## ADDENDUM NO. 1

Project: Sunnycrest Manor 3<sup>rd</sup> Floor Heat Pump Replacement

Issue Date: December 27, 2016

# COMMON AREA DUCT REVISION

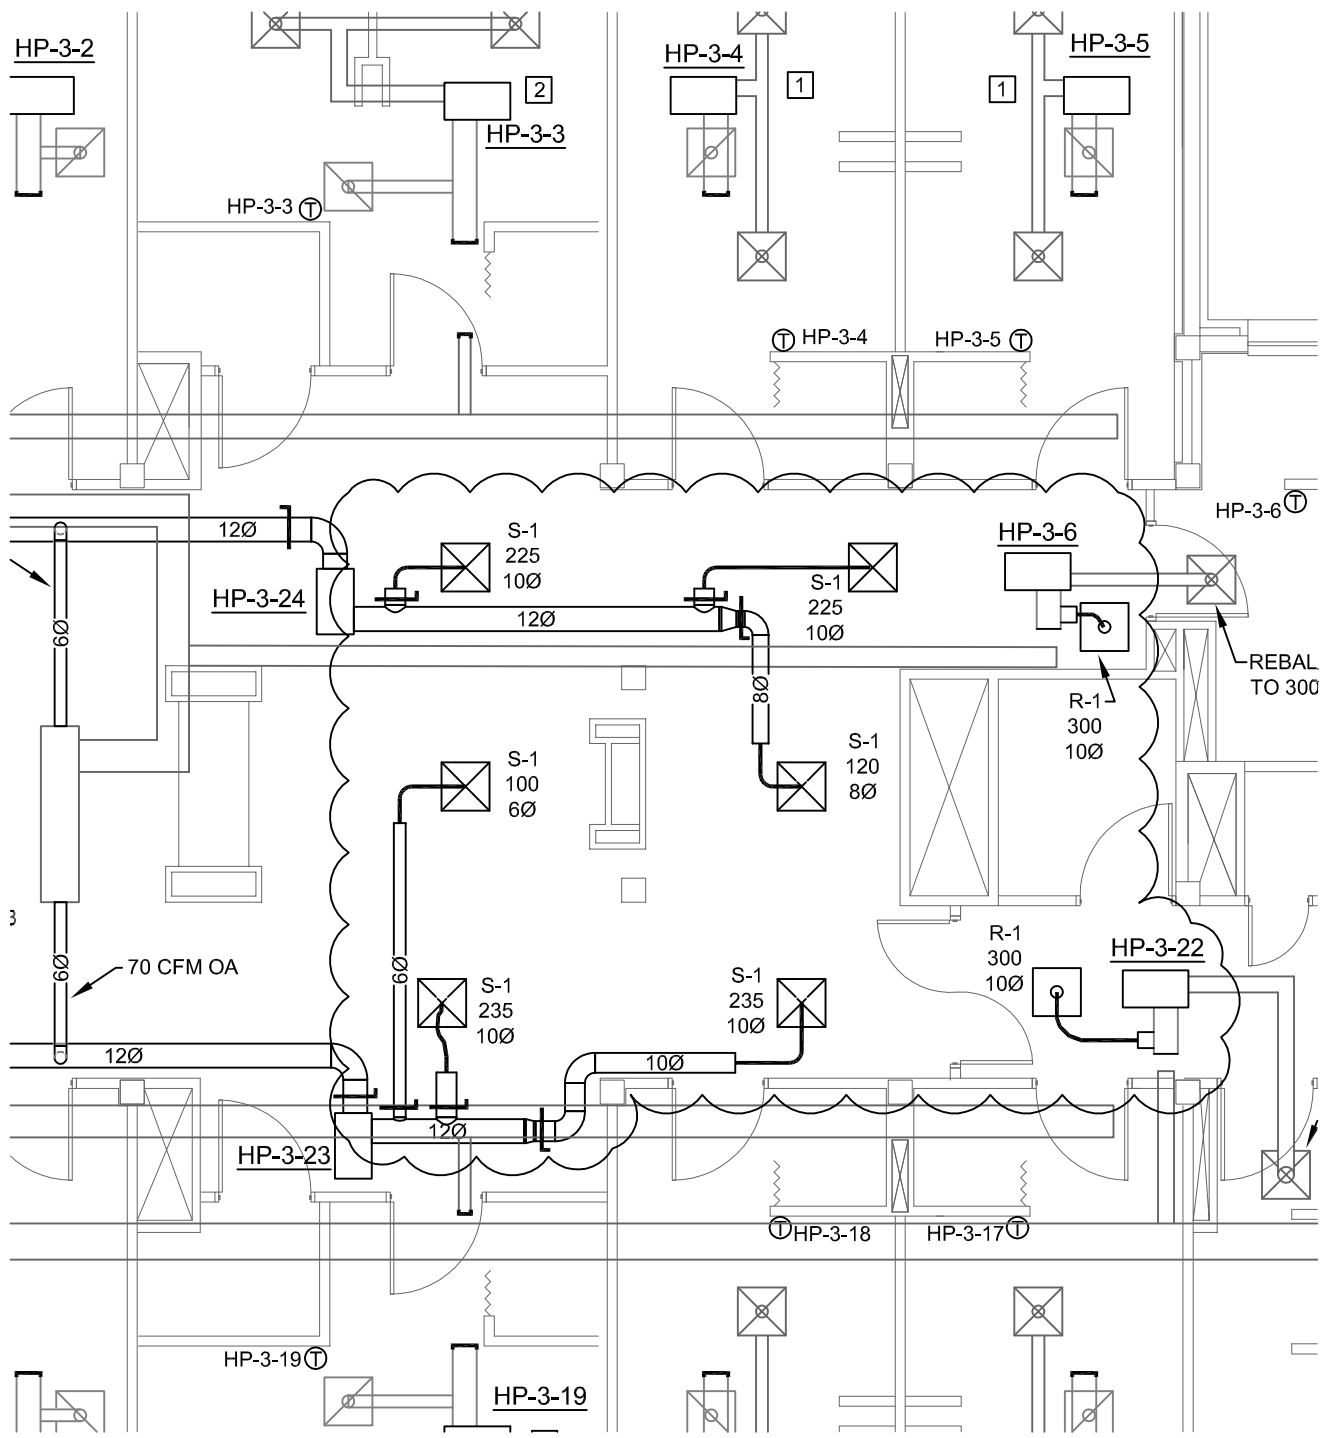
1. Sheet H1.1
  - a. Refer to attached "Addendum Drawing 1" for revised Common Area Ductwork.
  - b. Existing automatic balancing valves, contractor may either rebuild existing in place with new flow cartridge or remove existing cartridge and add new flow control assembly up stream of existing..
